# FLYING HORSE NORTH FILING NO. 2

A PORTION OF SECTION 36, TOWNSHIP 11 SOUTH,  
RANGE 66 WEST OF THE SIXTH PRINCIPAL MERIDIAN,  
EL PASO COUNTY, COLORADO

FLYING HORSE NORTH  
FILING NO. 2  
JOB NO. 1306.00  
JANUARY 3, 2022  
SHEET 1 OF 2

VICINITY MAP  
N.T.S.

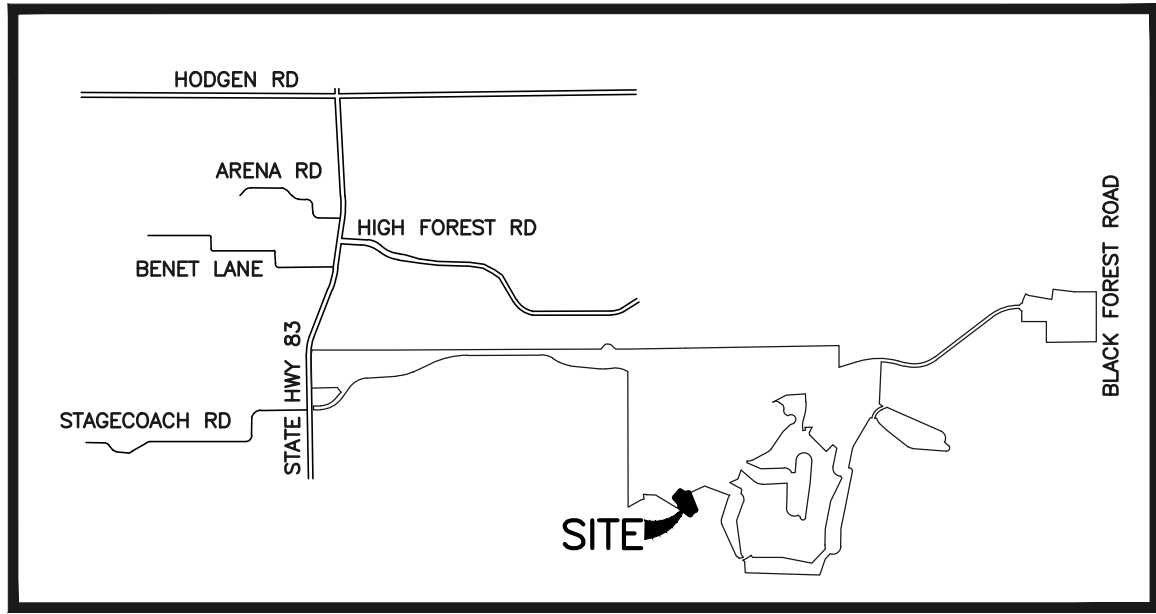
Should be a 10 ft  
public utilities, public  
improvement, and  
drainage easement  
per LDC Sec. 8.4.6
